Date of Issuance: June 20, 2024      Effective Date:  
 Owner: Town of Boonsboro      Owner's Contract No.:  
 Contractor: HRI, Inc.      Contractor's Project No.:  
 Engineer: Gwin, Dobson & Foreman, Inc.      Engineer's Project No.: 21061  
 Project: Boonsboro Sludge Dewatering Project      Contract Name: General - Mechanical

Description: Rerouting Utility Water Line (PCO2R1) - \$1,927.57  
 Snow Clips on Pole Barn Buildings (PCO3R1) - \$7,014.57  
 Sludge Truck Connection (PCO4) - \$6,599.86  
 Sludge Pump Check Valve (PCO5) - \$6,341.85  
 Microbioretention Area Changes (PCO6) - \$13,248.29

# WORK CHANGE DIRECTIVE

WORK CHANGE DIRECTIVE: No. 1

**ROTARY PRESS BUILDING FLOOR PLAN**

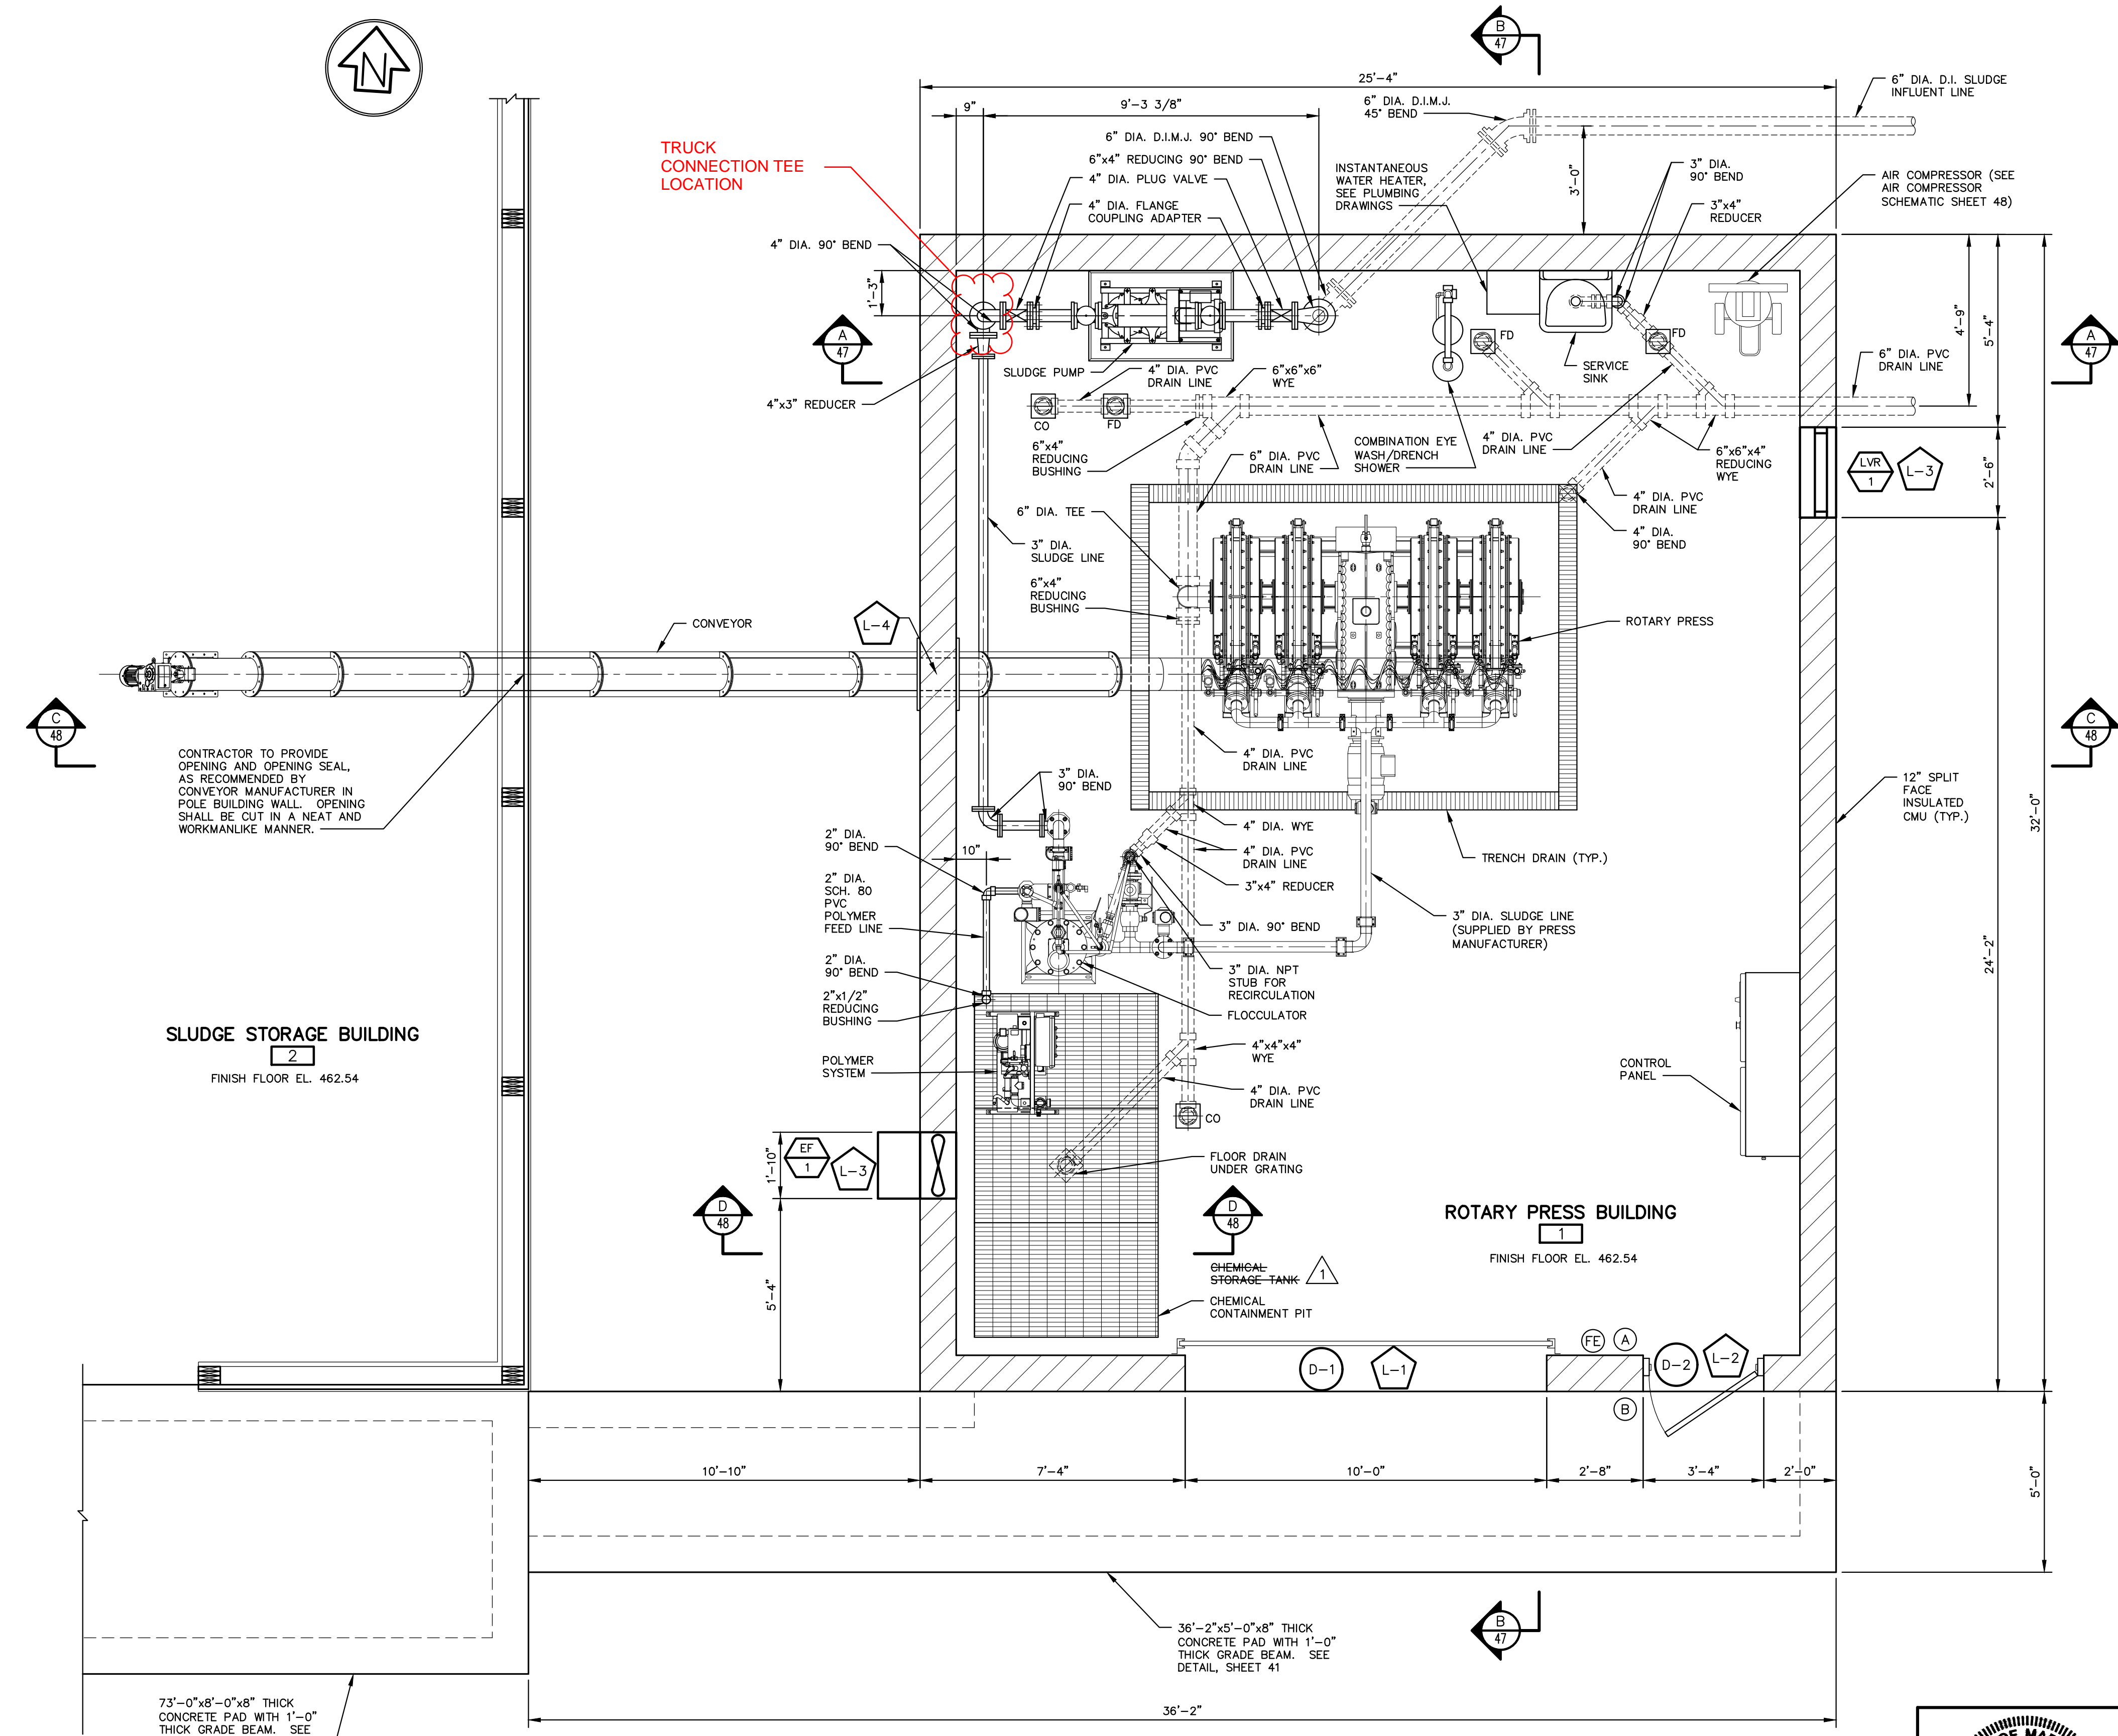
**Work Item:** Truck Connection to Sludge Piping

**Reference:** Sheet 40, 47 Markup

**Change to be Made:** Provide truck connection on discharge side of sludge pump in Press Building.

Remove existing 90-degree elbow on the discharge side of the sludge pump following the 4" Plug Valve. Provide 4" Ductile Iron Tee, 4" Ductile Iron Plug Valve, 4" Stainless Steel Piping (flanged connection to Plug Valve, threaded connection on exterior), and 4" quick connect fitting with dust cap on exterior of building as shown. Provide a minimum of 1' clearance between exterior of wall/quick connect fitting and provide wall closures as necessary for neat appearance.

**ROTARY PRESS BUILDING FLOOR PLAN**  
SCALE: 3/8" = 1'-0"

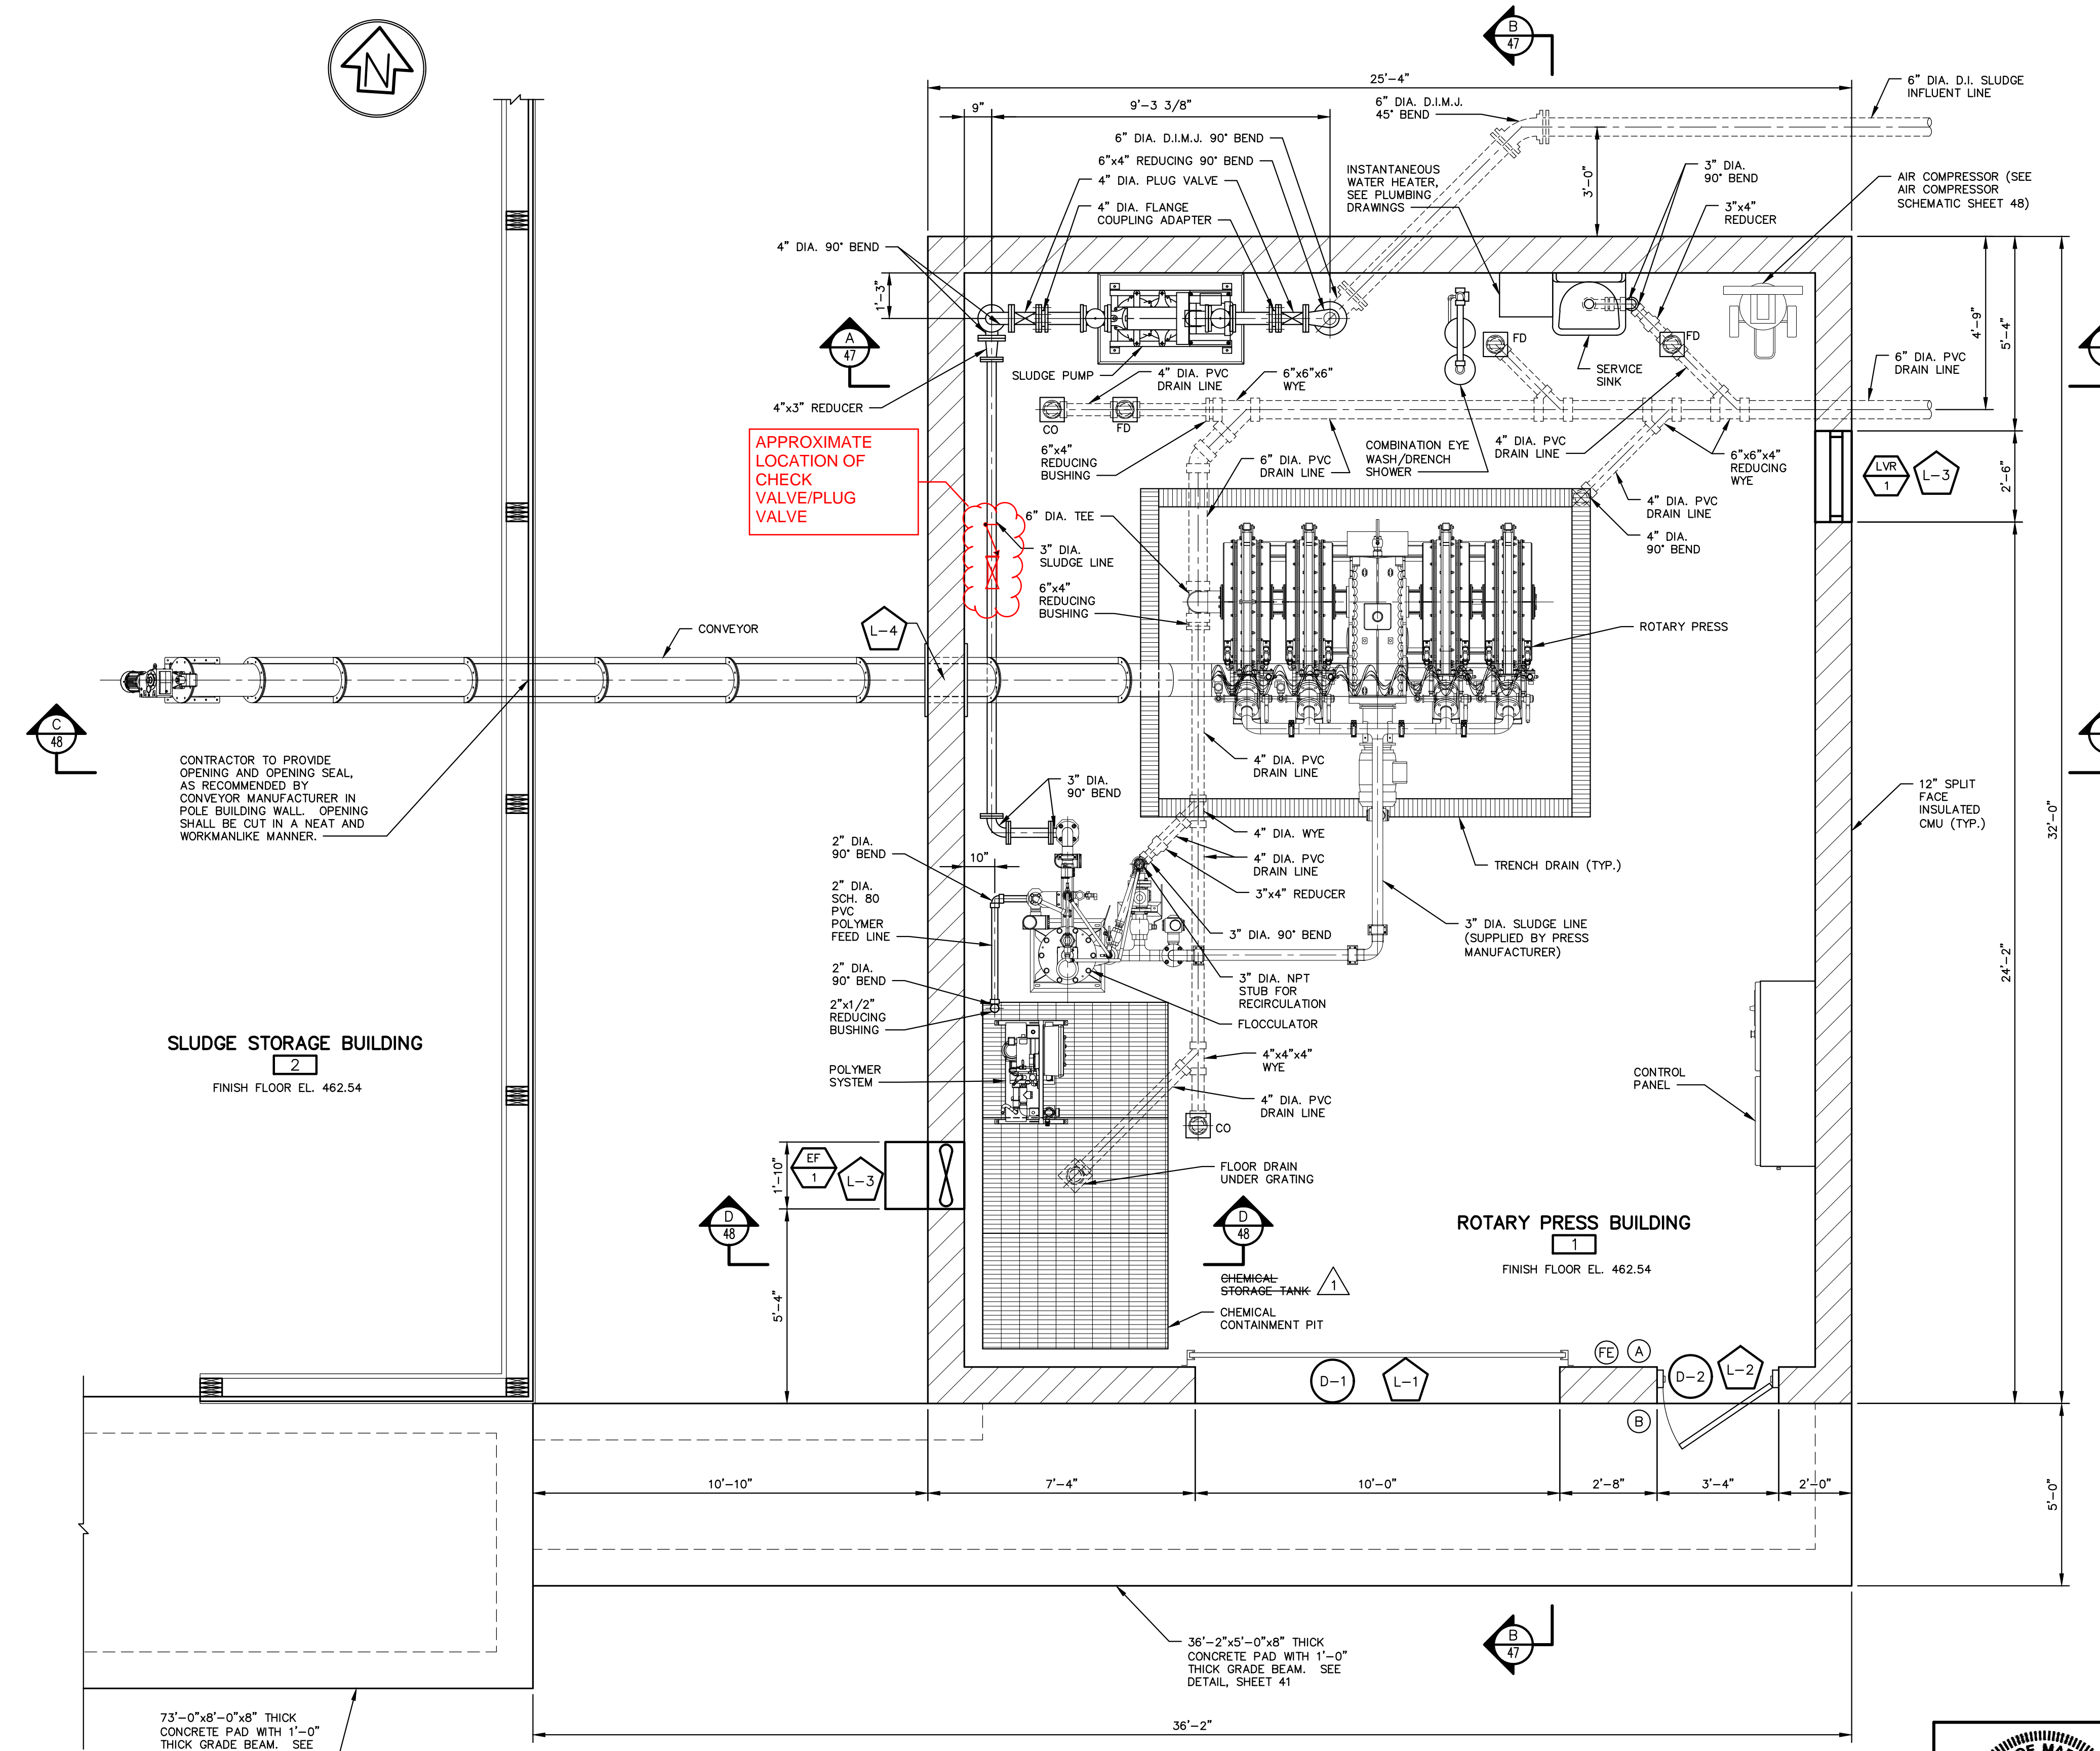
**Work Item:** Sludge Pump Check Valve

**Reference:** Markup of Sheet 40

**Change to be Made:** Provide 3" adjustable swing check valve (Model PVP759 with Spring Assembly on left side of flow direction when viewed from top, Penn Valley Pump), 3" plug valve, and flanged coupling adapters in approximate location shown on below markup. Final location to provide adequate clearance for servicing of the check valve.

APPROXIMATE LOCATION OF CHECK VALVE/PLUG VALVE
